Certified Action of the City of Raleigh Planning Commission Group Housing Development

Case File / Name: GH-1-12 / Bainbridge Six Forks

Staff Report

Proposed Site Plan

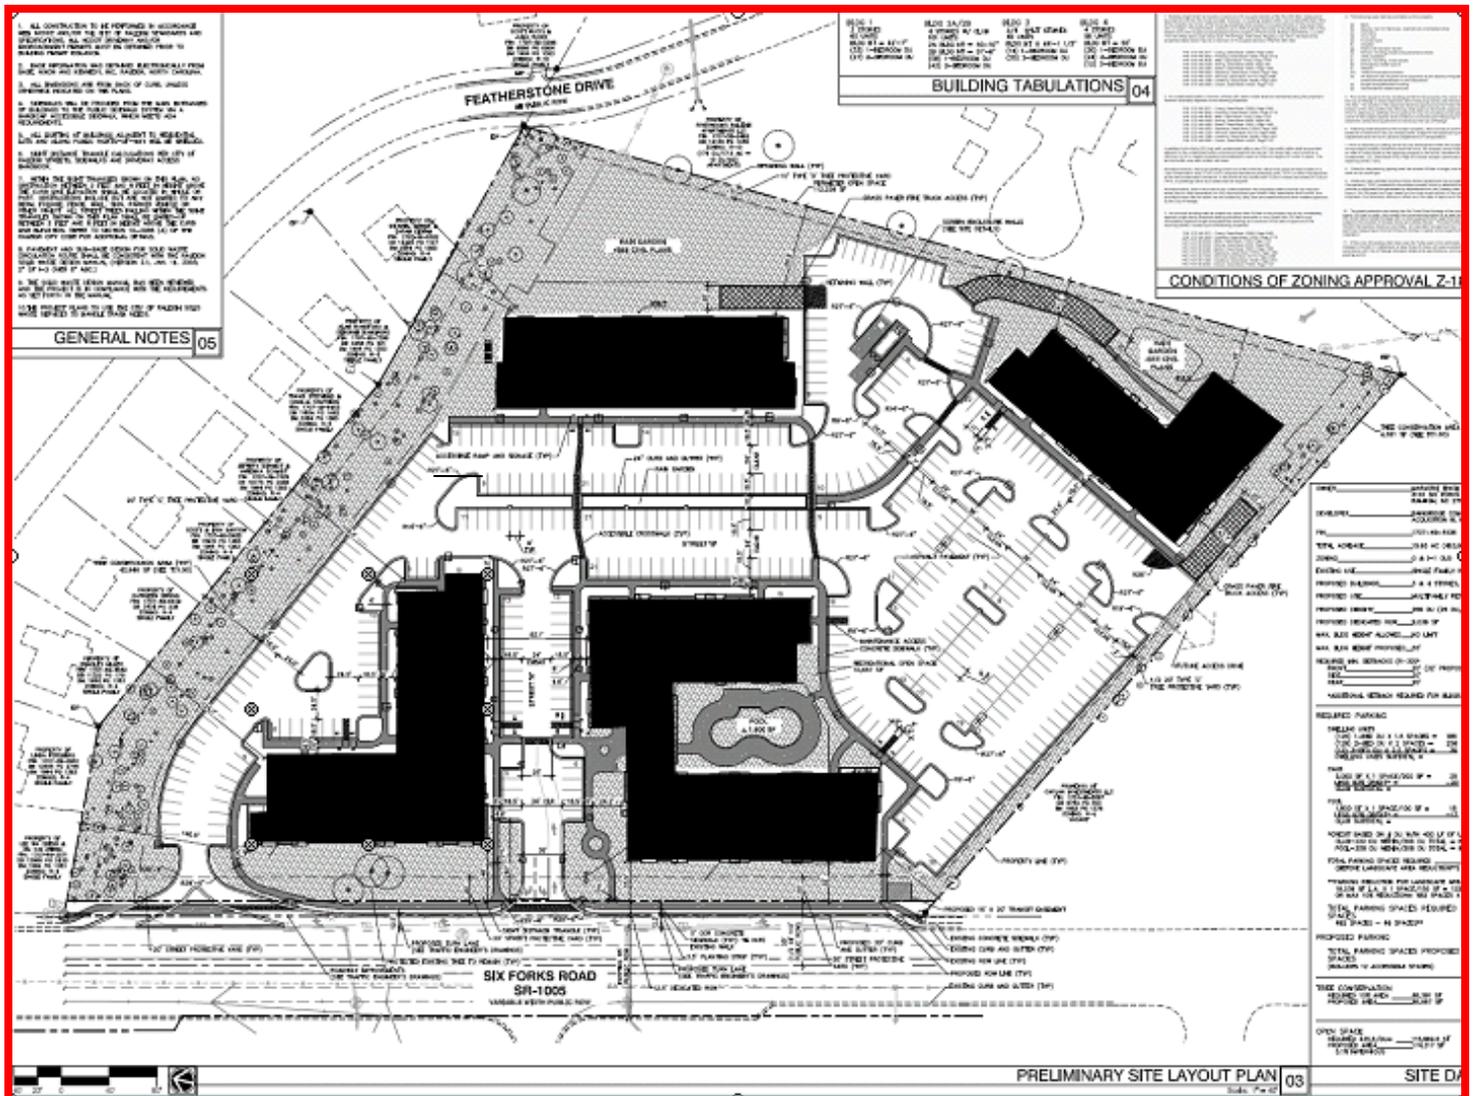
| <u>Comment</u> | <u>Response</u> |
|--|---|
| <p>1) The Commission commends the applicants on creating a visually-engaging streetwall via the building facades. The same approach merits added expression along Six Forks Road, especially in regard to pedestrian ways:</p> <p>a. As there are no primary street-side entrances to the street-proximate buildings, the main driveway and attendant pedestrian walks serve as the site “front door”. Further enhance the site entry through attractive landscaping and hardscape features to reinforce the sense of arrival [commensurate with Code Sec. 10-2132.2(d)(2)].</p> <p>b. Given traffic volume and speed on Six Forks Road, the planned width of street frontage space, and anticipated street design</p> | <p>a. Response: A low entry wall, monument signage, and landscaping has been added to enhance the entry and provide a sense of arrival.</p> <p>b. The public sidewalk has been placed six (6) feet off the back of curb along Six Forks Rd. as requested where possible to pull pedestrian travel away from traffic lanes. Street trees will need to remain with the 20’ street protective yard per conditions of Z-18-11 condition 10.</p> |

initiatives by both the City and NCDOT regarding sidewalk design, for both increased safety and improved aesthetics flip the placement of the proposed streetyard trees and the street sidewalk, such that the trees line the road with the sidewalk running between the trees and the buildings, for both increased safety and improved aesthetics [commensurate with Code Sec. 10-2132.2(d)(1) & (5)].

- 2) Provide a direct pedestrian connection through the southern portion of the proposed parking lot between Building 4 and the Building 2A area (club/ pool, and transit stop), rather than the more circuitous route proposed [commensurate with Code Sec. 10-2132.2(d)(1)].

Providing a second connection was considered but is impractical due to site and parking constraints. We feel that the pedestrian connection provided will adequately serve Building 4.
